CITY OF ALBUQUERQUE

RE: **417 Headingly Ave, N.E**
Grading Plan
Engineer's Stamp Date 3/6/18
Hydrology File: G14D090

**417 HEADINGLY AVE., NW
GRADING PLAN**

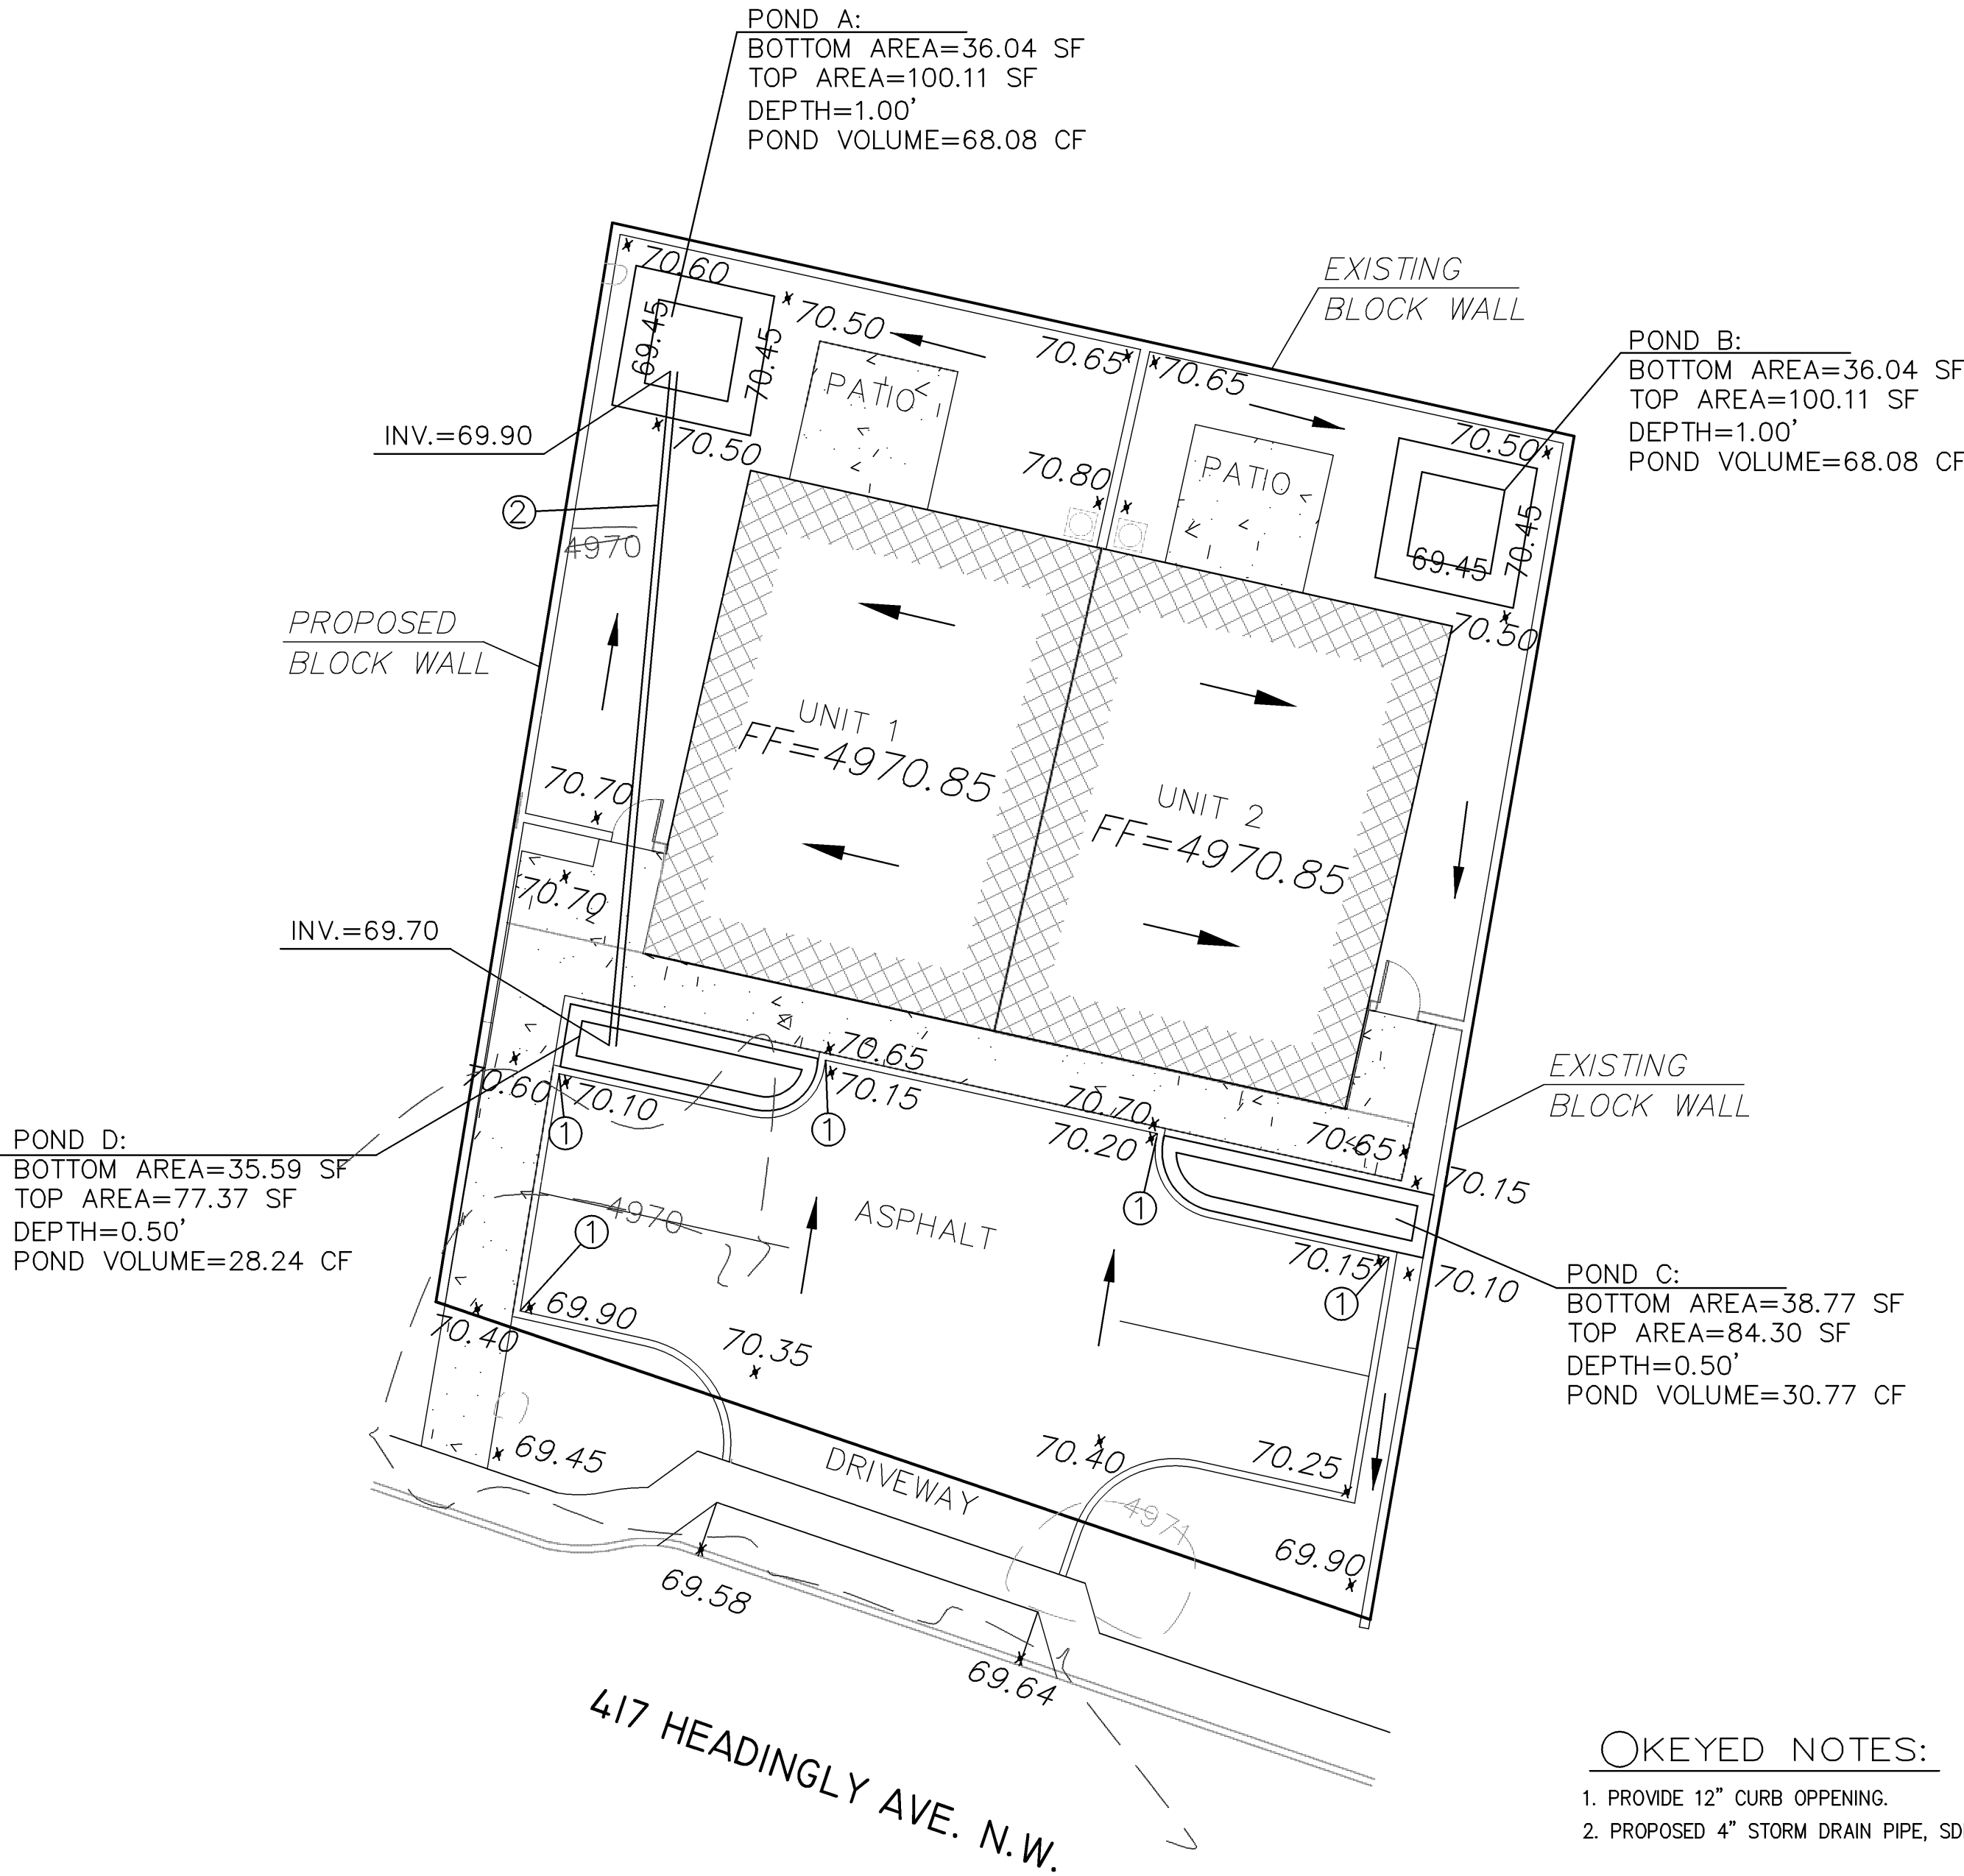
1. The site must demonstrate adequate downstream capacity per § 14-5-2-12(G) of the Albuquerque Code of Ordinances prior to authorizing any increase in runoff.
2. If downstream capacity cannot be demonstrated, onsite ponding of the increased runoff will be required.
3. It is recommended that the finished floor elevations be elevated at least 1 foot above the overflow to the street.

4. A Private Facility Drainage Covenant is required for the stormwater ponds. The original notarized form, exhibit A (legible on 8.5x11 paper), and recording fee (\$25, payable to City of Albuquerque) must be turned into DRC (4th, Plaza del Sol) for routing. Please contact Charlotte LaBadie (clabadie@cabq.gov, 924-3996) or Madeline Carruthers (mtafoya@cabq.gov, 924-3997) regarding the routing and recording process for covenants.
5. The site will need to be graded and Pad Certifications will be required prior to Hydrology approving the residential Building Permits.

6. Engineer's Certification, per the DPM Checklist, will be required to ensure the ponds remained intact following home construction.
7. The Private Facility Drainage Covenant must be recorded with Bernalillo County and a copy included with the drainage certification.
